UNITED STATES PATENT AND TRADEMARK OFFICE

APPLICATION NO.	FILING DATE	FIRST NAMED INVENTOR	ATTORNEY DOCKET NO.	CONFIRMATION NO.
10/599,033	10/26/2006	Philippe Bonny	203.802	3269
37004	7590	11/01/2007		
POWER DEL VALLE LLP 233 WEST 72 STREET NEW YORK, NY 10023			EXAMINER MISA, JOAN D	
			ART UNIT 4155	PAPER NUMBER
			MAIL DATE 11/01/2007	DELIVERY MODE PAPER

Office Action Summary	Application No.	Applicant(s)	
	10/599,033	BONNY ET AL.	
	Examiner	Art Unit	
	Joan D. Misa	4155

DETAILED ACTION***Oath/Declaration***

Reproduced from U.S. Patent No. 4,761,943.

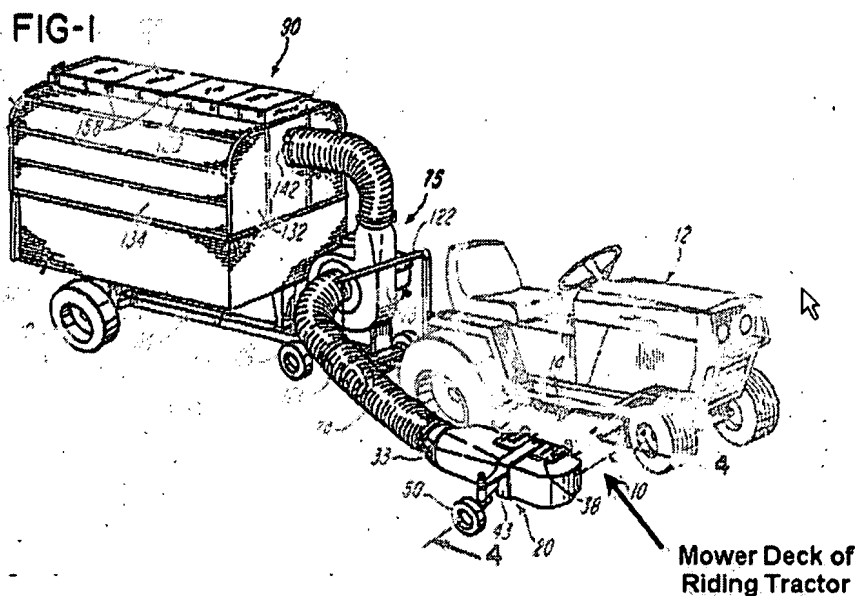
c. However, Parker et al. discloses a mower, which further includes a suction device (Fig. 1, "vacuum-blower unit" 75) mounted on the sleeve mounted on the side of the cutting device. The suction device as taught by Parker et al. allows the clippings to be collected and sent to a bag (bags installed in "cart" 90) to collect the clippings.

Modified Figure 1 of EP 0894429 A1

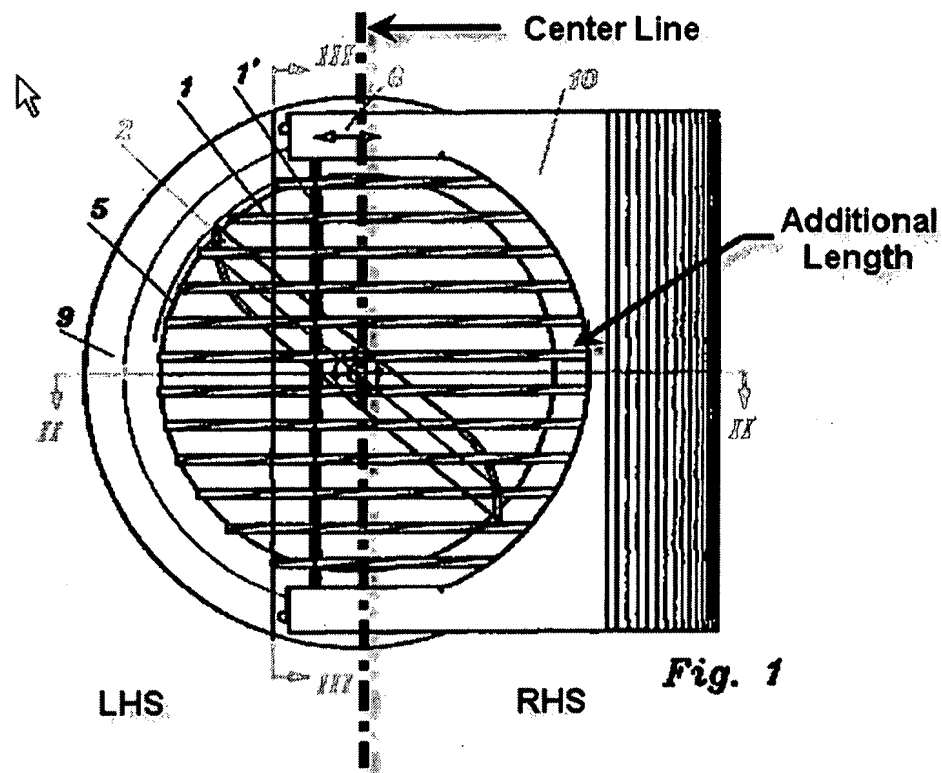
b. Petry discloses a leaf stripper, which includes "an apertured plate (Fig. 1, 9 and 5) that has straight rods (1 and 1') which forms a grill (1 and 1') and whose rods are longer on one side ...". When comparing the length of the rods, the right hand side (RHS) is longer than the left hand side (LHS) as provided by the centerline in figure 1 below.
